HOUSTON PLANNING COMMISSION

AGENDA

MARCH 31, 2016

ITEM: 90

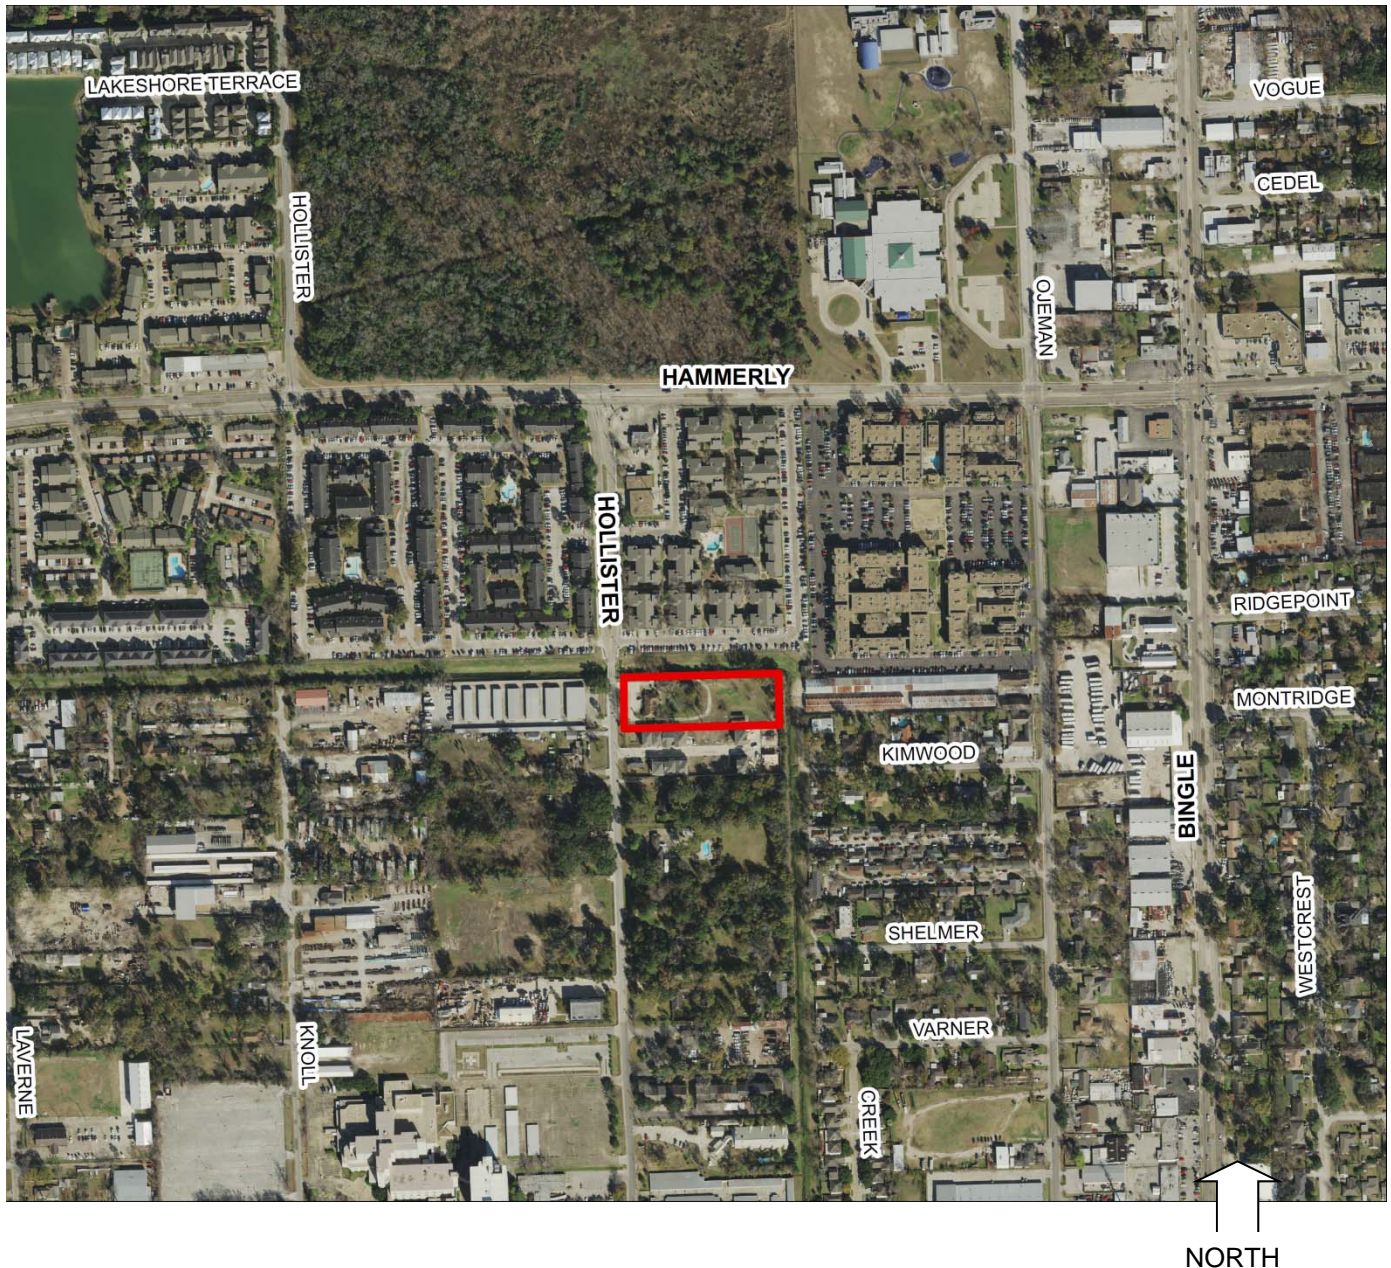
PWE Traffic: The current proposed placement of the parking is not acceptable. The required guest parking needs to be placed on-site or on-street if permitted. The survey lists the street width as 28 feet from curb to curb, but that will need to be verified. The current proposed placement would restrict the extension of the sidewalk which is required for new developments.
